LAWRENCE HISTORIC RESOURCES COMMISSION
AGENDA FOR **JANUARY 19, 2017**
CITY HALL, 6 E 6TH STREET
6:30 PM

LAWRENCE HISTORIC RESOURCES COMMISSION
ITEM NO. 4: DR-16-00497
STAFF REPORT

LAWRENCE HISTORIC RESOURCES COMMISSION
ITEM NO. 6: DR-16-00530
STAFF REPORT

1905

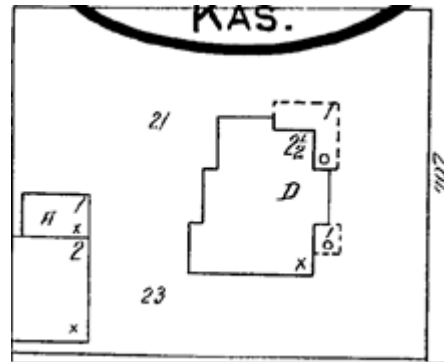
Sanborn Fire Insurance maps show an accessory structure at this location as early as 1905. This map indicates that the structure was a type of stable that was 1½ stories with an addition to the north. This one story addition has altered in size by the 1918 map and the main portion of the structure is now identified as two stories. By 1927, the accessory structure is identified as a two story structure with a different footprint and a slightly different location. The one story addition is identified as a wood frame structure used as a private garage. The 1949 map also shows this pattern and identification. The appraiser's office identifies a storage building on the parcel with a construction date of c. 1930.

Attached Garage

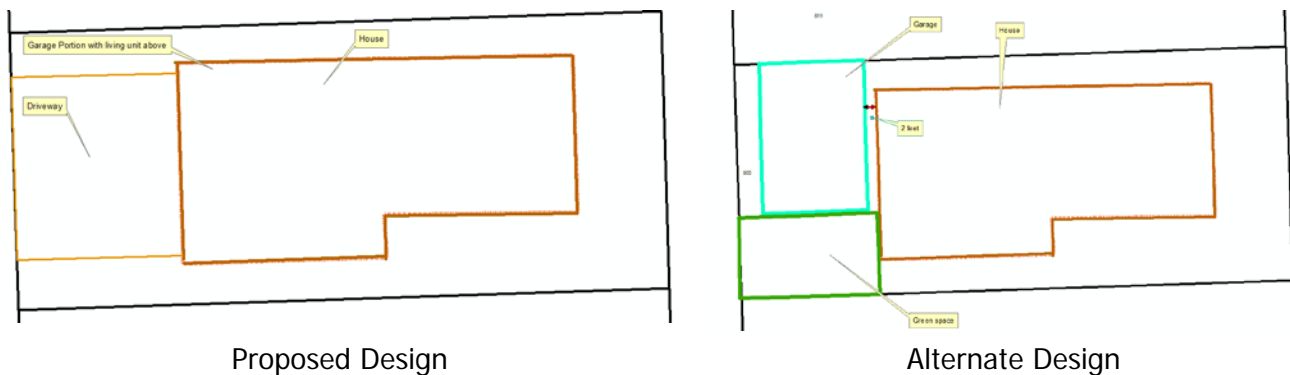
Attached garages are not typical in the environs of the listed property. Most of the structures in the environs and in the block have detached garages or storage buildings. Attached garages are a suburban form created after the increase in automobile ownership and use. This suburban form did not transfer to the majority of the structures in the historic areas of East Lawrence. While attached garages do exist in the historic area, they are primarily associated with new construction or dated post 1950.

Staff does not recommend attached garages in the environs of a listed property. Garages that are attached typically increase both the footprint of the primary structure and create a loss of rear yard green space thus disrupting the spacial relationships in the environs. This proposed project will remove all of the rear yard green space for the associated driveway with the exception of a small area to both sides of the driveway for a total of approximately 336 square feet. This driveway will

disrupt the rear yard green space rhythm that is dominate in the environs of the listed property.

The garage portion of the project is located below the 2nd duplex unit. If the garage portion of the project was removed from the proposed design, the footprint of the structure would likely not significantly change because the 2nd duplex would then be placed at the ground level. If the unit were placed on the ground rather than above the garage, a three car garage could be placed adjacent to the alley but this would remove approximately the same amount of green space from the rear yard. However, the reduction in green space in this manner would allow for a concentrated green space area that would increase the overall compatibility of the structure by creating a rear yard similar to the spacial pattern of the environs of the listed property.

Staff recommends the commission discuss opportunities and challenges for the attached garage and the fenestration pattern for the north elevation.
